<b>DART</b> AEROSPACE	
TITLE	
ENGINE WASH UNIT	
DWG NO.	
HT-500-CWA	
REV 10	
MAT'L	
UNLESS OTHERWISE SPECIFIED DIMENSIONS ARE IN INCHES	
HEAT      XXX $\pm$ .005      FRACTIONS $\pm$ 1/8	
TREAT      XX $\pm$ .01      ANGLES $\pm$ 5°	
FINISH      X $\pm$ .1      SURFACES = 125	
SPEC	
DRAWN BY: NELSON	
CHECKED: DUERFELDT	
OPPS APPR: ANDERSON	
QA APPR: LINDSAY	
APPROVED: GILBERT	
SCALE	1:10
DATE	7/15/2014
SHEET 3 OF 32

## WORK ORDER NON-CONFORMANCE / UPDATE

FRAME WELDMENT

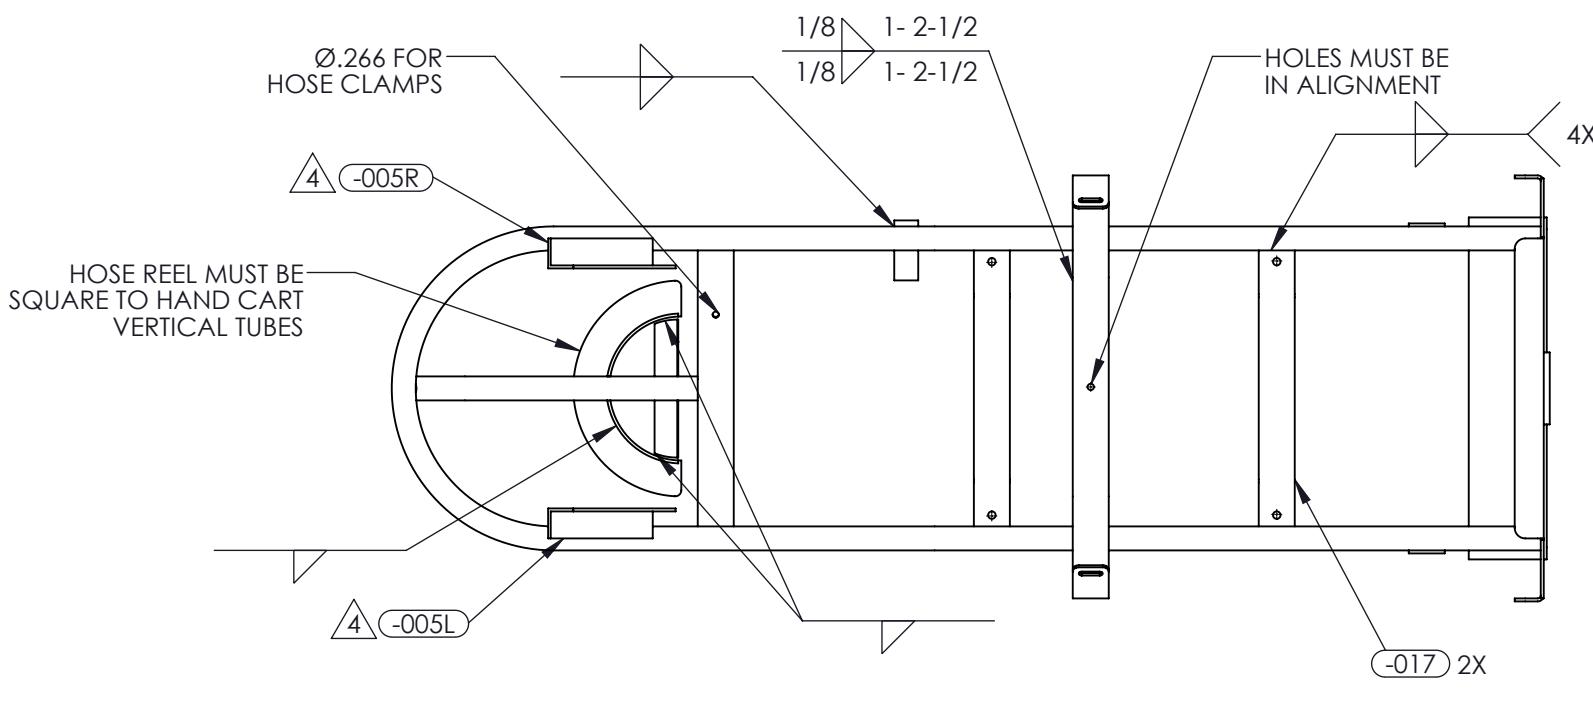
REVISIONS					
REV	ECR	DESCRIPTION	DATE	INITIAL	APPROVED
7	14-0131	-001 CH'D FINISH WAS POWDER COAT T-5920 S9 YELLOW RIBBON IS POWDER COAT YELLOW FED #13538.	7/28/2014	DJN	RJC
9	16-0205	-001 CH'D DIM WAS 37.25 IS 2X 37.25, CH'D DWG TO SHEET METAL TOLERANCE.	11/21/2016	RJC	JAG
10	17-0058	-001 DELETED HAND TRUCK BLADE CUT TO 4.25 NOTE.	5/22/2017	DPD	JAG

PAN

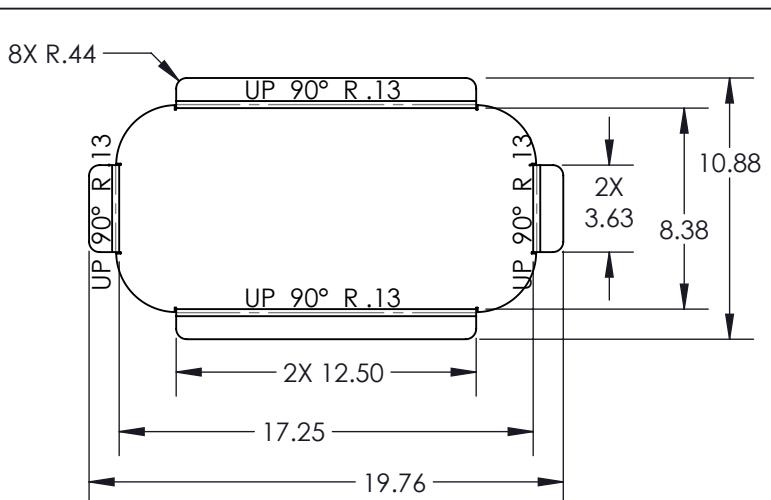
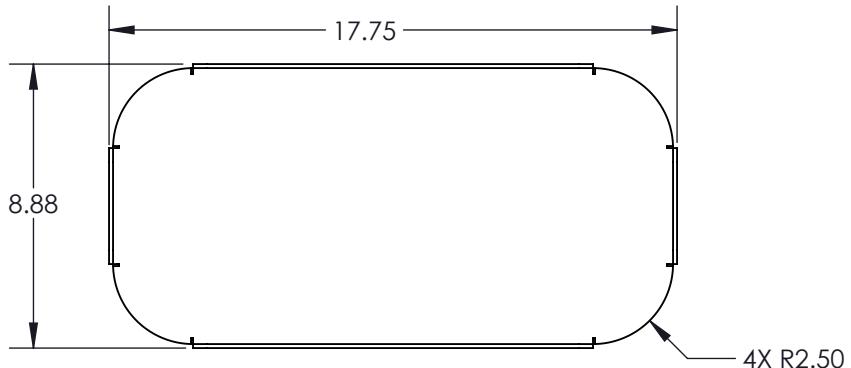
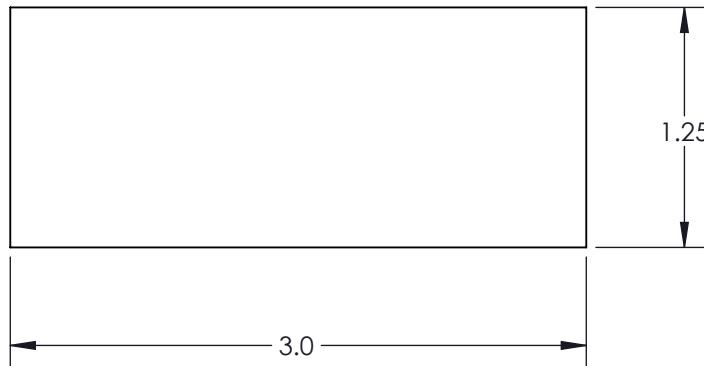
REVISIONS					
REV	ECR	DESCRIPTION	DATE	INITIAL	APPROVED
7	14-0131	-003 CH'D DIM WAS 1.25 IS 4X 1.21.	7/28/2014	DJN	RJC
9	16-0205	-003 CH'D DIM WAS 8.75 IS 8.88, WAS (.125) IS .13, CH'D DWG TO SHEET METAL TOLERANCE.	11/21/2016	RJC	JAG

BOX MOUNT

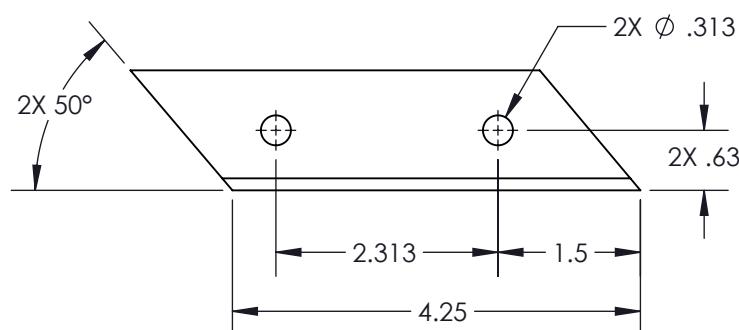
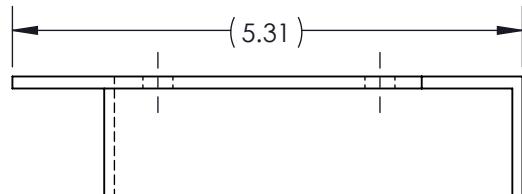
REVISIONS			
REV	ECR		DESCRIPTION	DATE	INITIAL	APPROVED
7	14-0130		-005R CH'D B/O INFO WAS 5-5/16 IS 5-7/16.	7/28/14	DJN	RJC
9	16-0205		-005R CH'D DIMS WAS (.13) IS .13 WAS (.125) IS 1.25, WAS (.125) IS 1.25, WAS .63 IS 2X .63, WAS 2.31 IS 2.313, DELETED DIM .75, CH'D DWG TO SHEET METAL TOLERANCE.	11/21/2016	RJC	JAG

BOX MOUNT

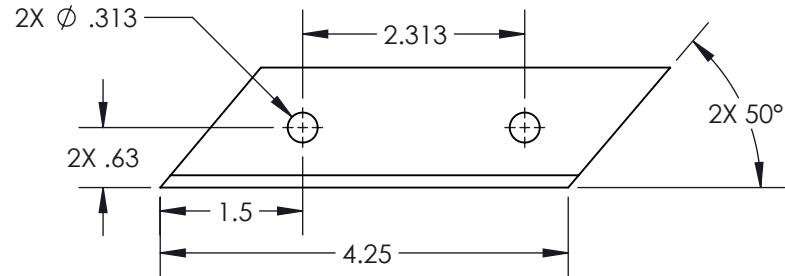
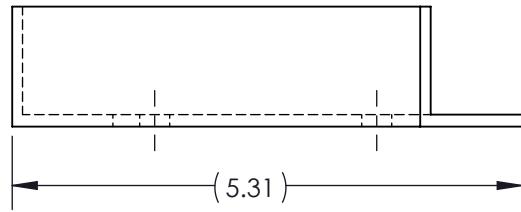
REVISIONS					
REV	ECR	DESCRIPTION	DATE	INITIAL	APPROVED
7	14-0131	-005L CH'D B/O INFO WAS 5-5/16 IS 5-7/16.	7/28/14	DJN	RJC
9	16-0205	-005L CH'D DIMS WAS (.13) IS .13, WAS (1.25) IS 1.25, WAS (1.25) IS 1.25, WAS .63 IS 2X .63, WAS 2.31 IS 2.313, DELETED DIM .75, CH'D DWG TO SHEET METAL TOLERANCE.	11/21/2016	RJC	JAG

MANIFOLD

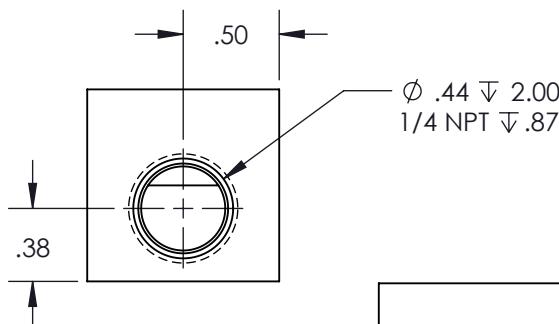
REVISIONS			
REV	ECR		DESCRIPTION	DATE	INITIAL	APPROVED
7	14-0131		-006 CH'D DIMS WAS 1/4 NPT $\nabla$ 1.052 IS $\phi$ .44 $\nabla$ .84 1/4 NPT, WAS $\phi$ .526 $\nabla$ 2.00 1/4 NPT IS $\phi$ .44 $\nabla$ 2.00 1/4 NPT, WAS 1.00 IS (1.00), WAS 1.00 IS (1.00), DELETED DIM .87 AND .84.	7/28/2014	DPD	RJC
9	16-0205		-006 CH'D DIMS WAS (1.00) IS 1.00, WAS (1.00) IS 1.00, WAS $\phi$ .44 $\nabla$ .84 1/4 NPT IS $\phi$ .44 $\nabla$ .84 1/4 NPT $\nabla$ .50, WAS $\phi$ .44 $\nabla$ 2.00 1/4 NPT IS $\phi$ .44 $\nabla$ 2.00 1/4 NPT $\nabla$ .87.	11/21/2016	RJC	JAG

HOSE HANGER

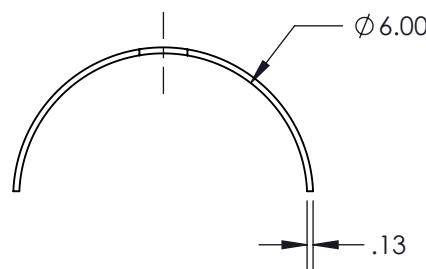
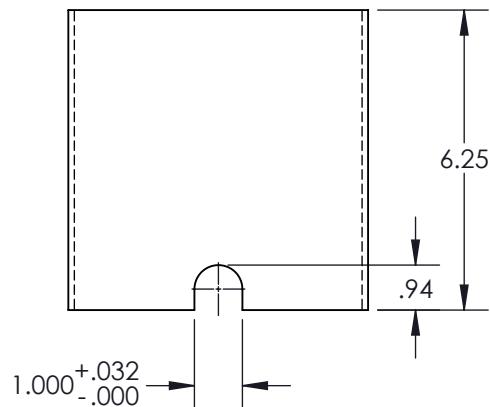
REVISIONS					
REV	ECR		DESCRIPTION	DATE	INITIAL
7	14-0131	-007	CH'D DIMS WAS .125 IS (.125), WAS Ø6 IS (Ø6). ADDED NOTE.	7/28/2014	DPD
9	16-0205	-007	CH'D DIM WAS (.125) IS .13, WAS (Ø6) IS Ø6.00, CH'D DWG TO SHEET METAL TOLERANCE.	11/21/2016	RJC
			JAG

BRACE

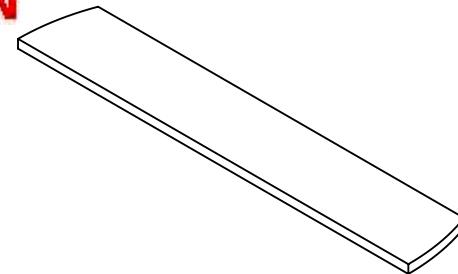
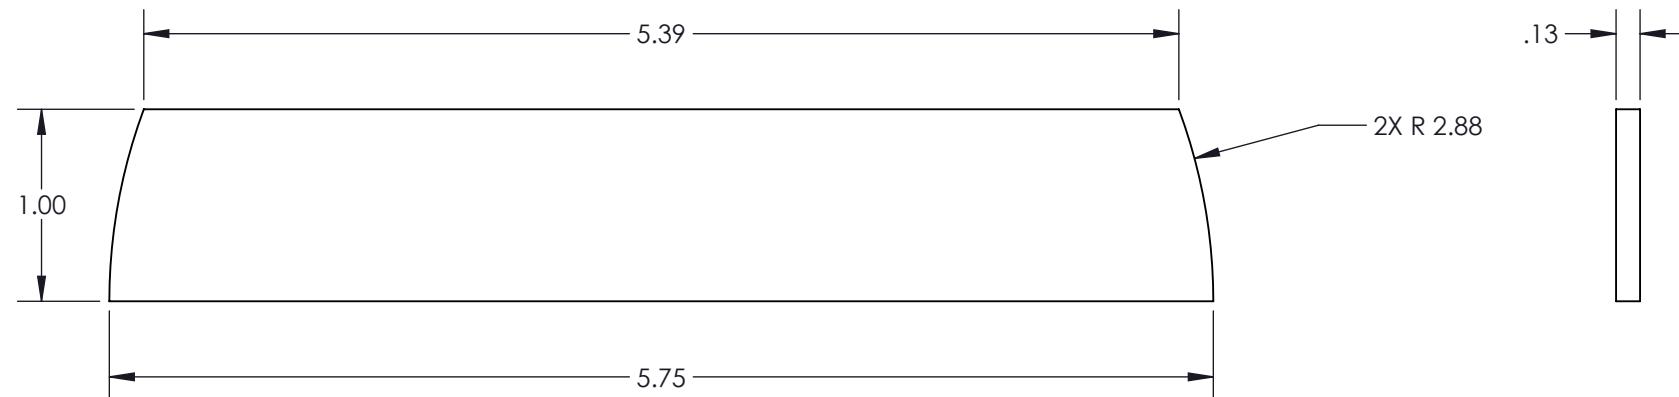
REVISIONS							
REV	ECR	DESCRIPTION			DATE	INITIAL	APPROVED
9	16-0205	-007A	CH'D DIMS WAS Ø5.75 IS 5.75, WAS (.13) IS .13, ADDED DIM 5.39, CH'D DWG TO SHEET METAL TOLERANCE.		11/21/2016	RJC	JAG

HANGER RIM

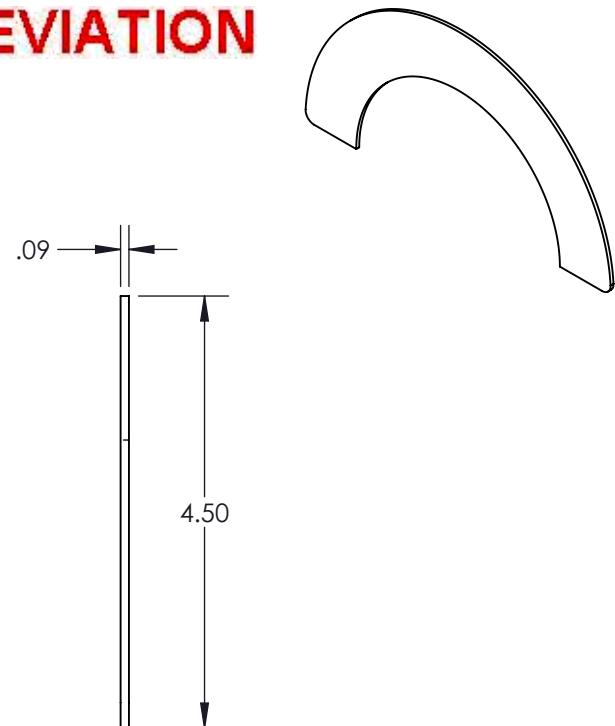
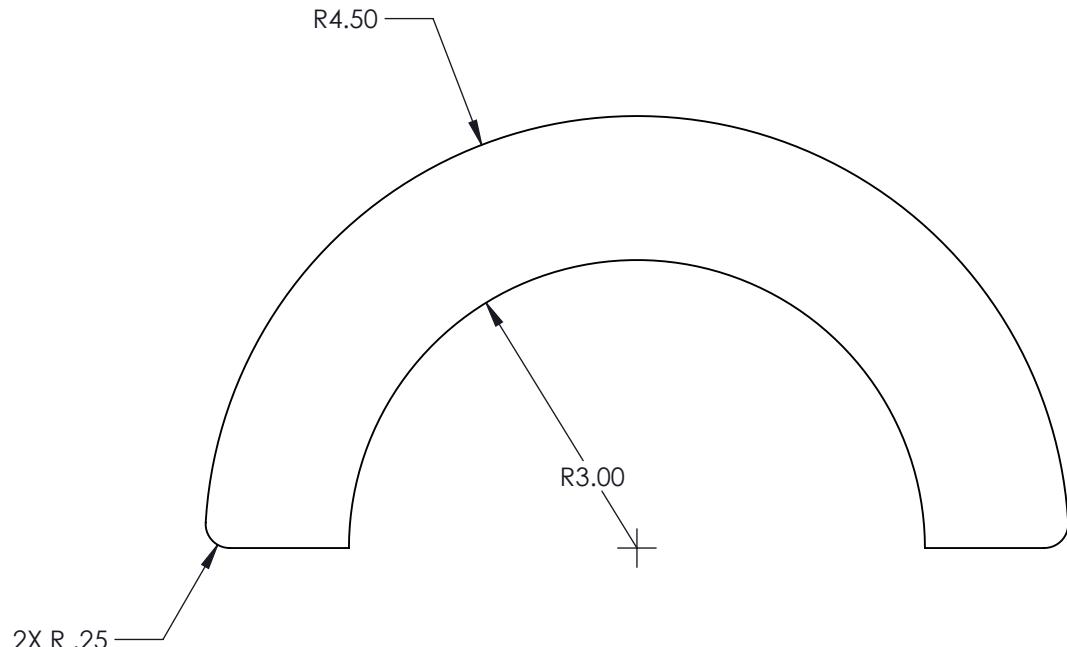
REVISIONS					
REV	ECR	DESCRIPTION	DATE	INITIAL	APPROVED
7	14-0131	-008 CH'D DIM WAS .087 IS (.087).	7/28/2014	DJN	RJC
9	16-0205	-008 CH'D DIM WAS (.087) IS .09, CH'D DWG TO SHEET METAL TOLERANCE.	11/21/2016	RJC	JAG

BOX MT BAR

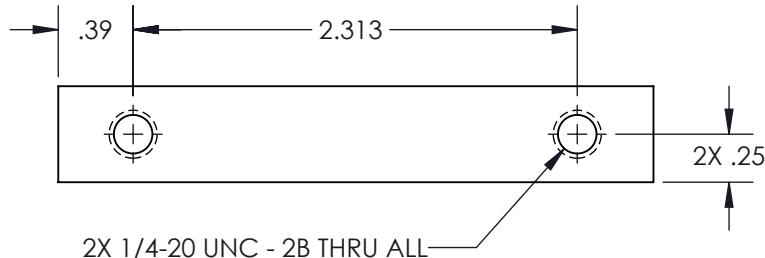
REVISIONS					
REV	ECR	DESCRIPTION	DATE	INITIAL	APPROVED
7	14-0131	-012 CH'D DIM WAS .25 IS 2X .25, WAS .25 IS (.25).	7/28/2014	DPD	RJC
9	16-0205	-012 CH'D DIM WAS (.25) IS .25, WAS 2.31 IS 2.313, CH'D DWG TO SHEET METAL TOLERANCE.	11/21/2016	RJC	JAG

BAND MOUNT

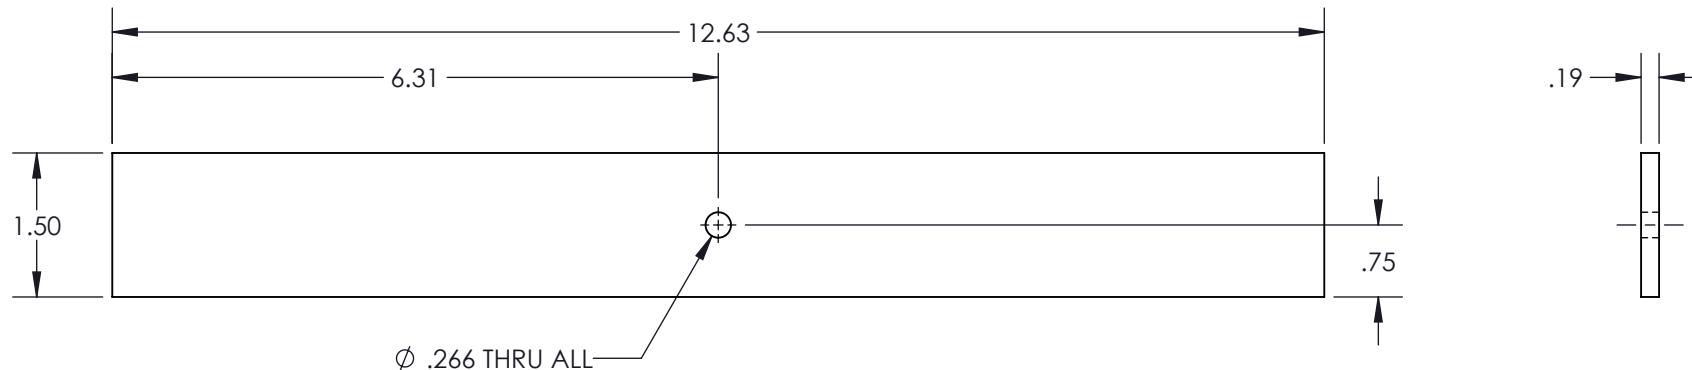
REVISIONS					
REV	ECR	DESCRIPTION	DATE	INITIAL	APPROVED
7	14-0131	-013 CH'D DIM WAS .188 IS (.188).	9/11/2014	DJN	RJC
9	16-0205	-013 CH'D DIMS WAS (.150) IS 1.50, WAS (.188) IS .19, CH'D DWG TO SHEET METAL TOLERANCE.	11/21/2016	RJC	JAG

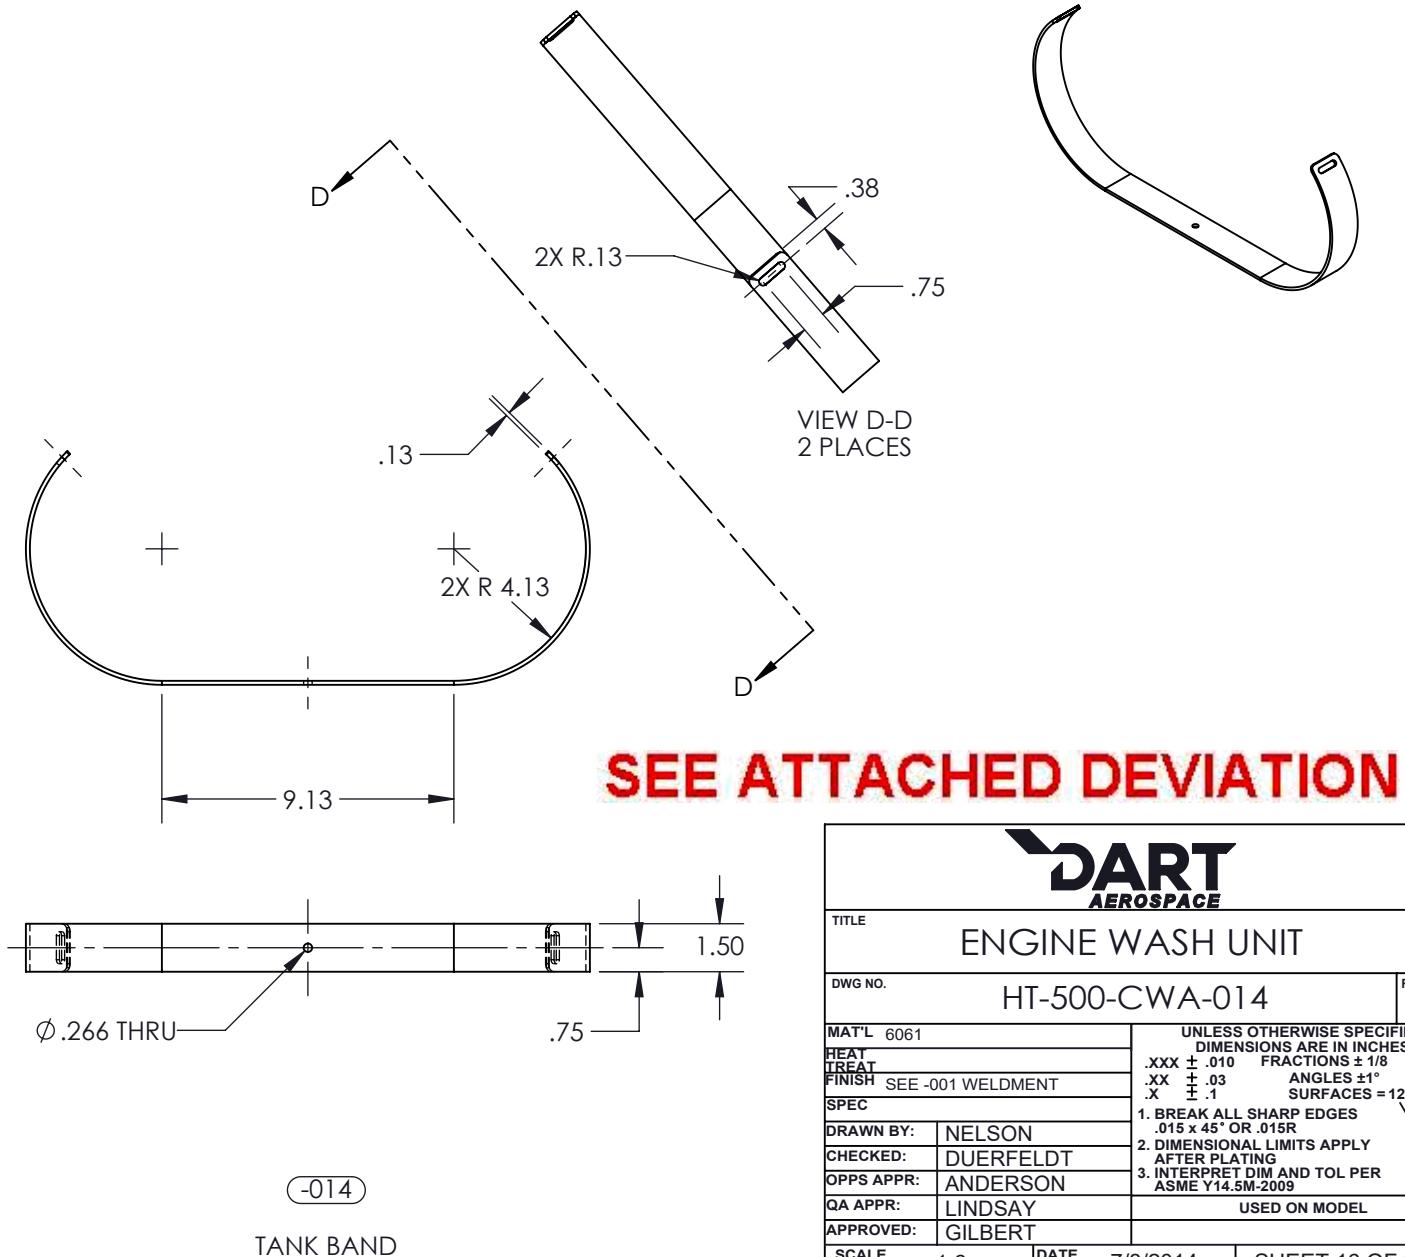
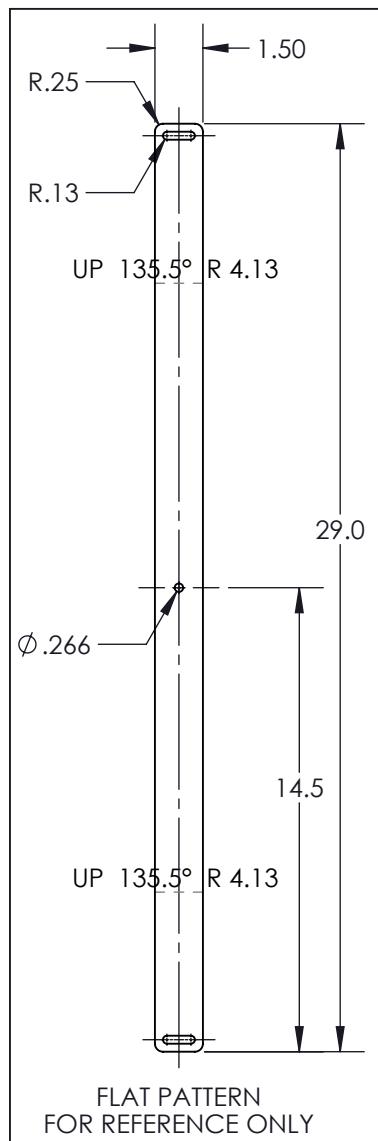
REVISIONS					
REV	ECR	DESCRIPTION	DATE	INITIAL	APPROVED
7	14-0131	-014 CH'D DIMS WAS .125 IS (.125), WAS 1.50 IS (1.50).	9/11/2014	DJN	RJC
9	16-0205	-014 CH'D DIM WAS (.125) IS .13, WAS (1.50) IS 1.50, ADDED DIM 1.50, Ø.266 THRU, CH'D DWG TO SHEET METAL TOLERANCE.	11/21/2016	RJC	JAG
10	17-0058	-014 ADDED DIM 2X R.13.	3/6/2017	DPD	JAG

FLUID TANKS CLAMP BAND

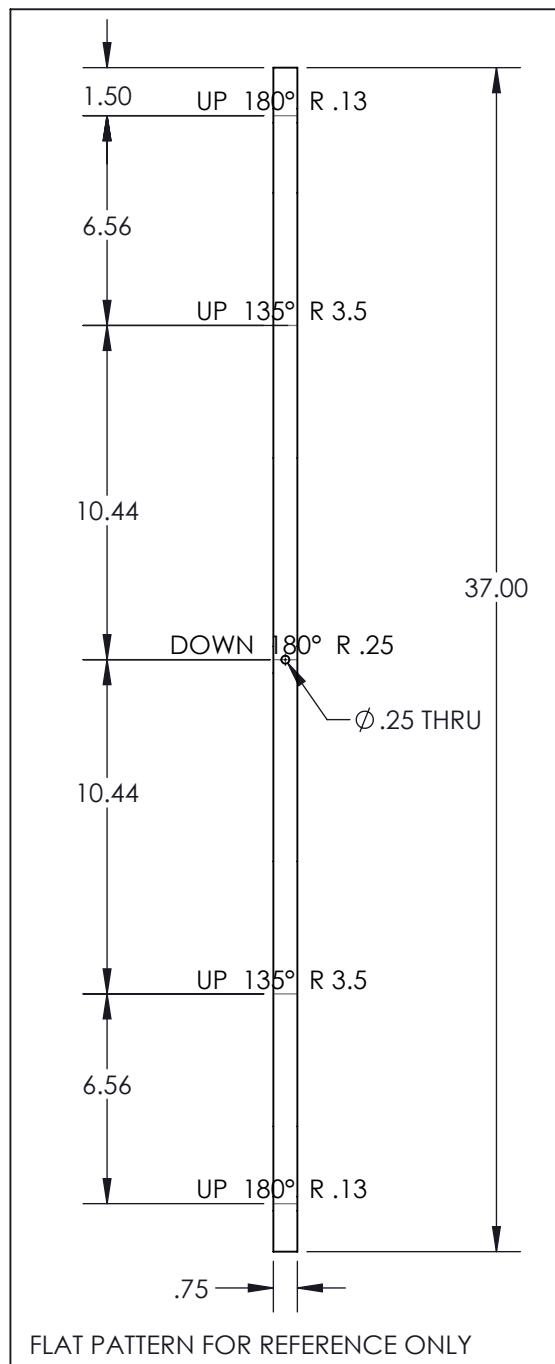
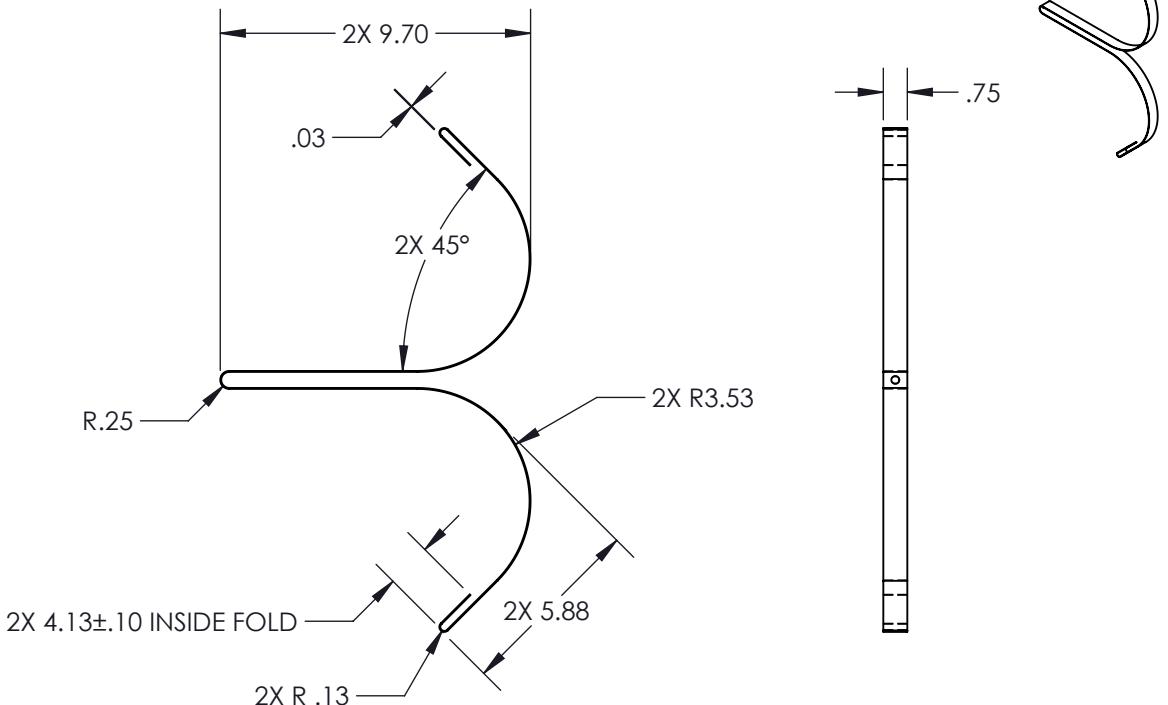
REVISIONS			
REV	ECR		DESCRIPTION	DATE	INITIAL	APPROVED
7	14-0131		-016 ADDED DIMS 2X R.13, R.25, AND .75.	7/28/2014	DPD	RJC
9	16-0205		-016 CH'D DIMS WAS (.031) IS .03, WAS (.75) IS .75, WAS 2X 4.13±.1 IS 2X 4.13±.10, ADDED DIMS 2X 9.70, 2X 45°, 2X R3.53, 2X 5.88, CH'D DWG TO SHEET METAL TOLERANCE.	11/21/2016	RJC	JAG
